| Title: Upgrade from Rotor System I to Rotor System II | | |
| AG-SB-2025-04-C-EN | Effective Date: 25.07.2025 | Compliance Category: A – MANDATORY B – RECOMMENDED C - OPTIONAL |
| Aircraft type & model: AutoGyro MT-03 AutoGyro MTOsport (2010,"classic") Calidus | Affected Serial number(s): If fitted with Rotor System I | |

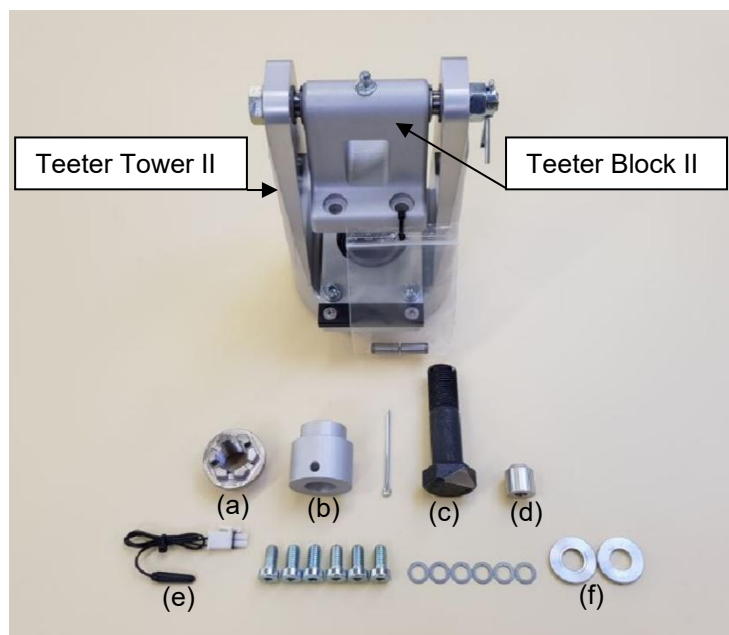
The newer Rotor System II 8,4m standard (red end caps, 8,4m TOPP (blue end caps) or 8,6m standard (grey end caps) is used with Teeter tower II.

An original Rotor System I (black end caps) must NEVER be fitted to a teeter tower II.

Conversion Set Rotor Head II 31895

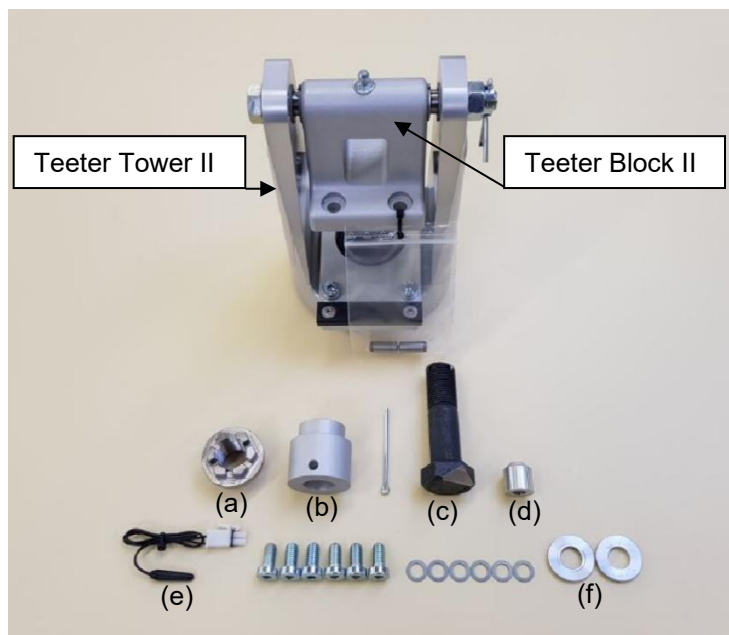
1. Remove the Rotor System in accordance with AMM job card 62-11-00 4-1.
2. Remove the teeter tower with crown gear assembly in accordance with AMM job card 62-20-00 8-1.
3. Replace the teeter tower I with the teeter tower II from the conversion set Rotor Head II (Part number 31895). It is strongly recommended that the aluminium spacer (b), main bolt (c) and nut (a) also be replaced. The spacer (d) is required for early versions of Calidus only.
4. It is also strongly recommended that the teeter bolt, washer and nut be replaced with the items from set (Part number 31895).
5. The temperature sensor (e) is included should the original item be damaged on disassembly. The sensor is assembled into the spacer using hot-glue. The sensor is orientated forward on assembly.
6. It is recommended also to replace spacers (f) so that Rotor balancing starts from a neutral point.

7. Remove the gimbal from the lower Rotor Head assembly and confirm the version fitted. AMM job card 62-32-00 0-1 refers. Although a gimbal Head I is acceptable, it is highly recommended to replace with a gimbal Head II, part number 33615.
8. If required, replace the gimbal in accordance with AMM job card 62-32-00 8-1.

9. Re-assemble the teeter tower/main crown gear assembly in accordance with AMM job cards 62-20-00 8-1, 62-31-00 5-1 & 63-11-30 6-1.
10. Assemble the teeter block II delivered with the conversion set Rotor Head II 31895 to the new Rotor System (Rotor System article numbers are stated in the "List of Components" table below).
11. Assemble the new Rotor System and fit on the aircraft in accordance with AMM job card 62-11-00 4-4.
12. If the original rotor is to be retained in service, then the hours in service and hours remaining should be clearly marked on the rotor assembly by way of a suitable label.
13. Proceed to the section **Final Steps**.
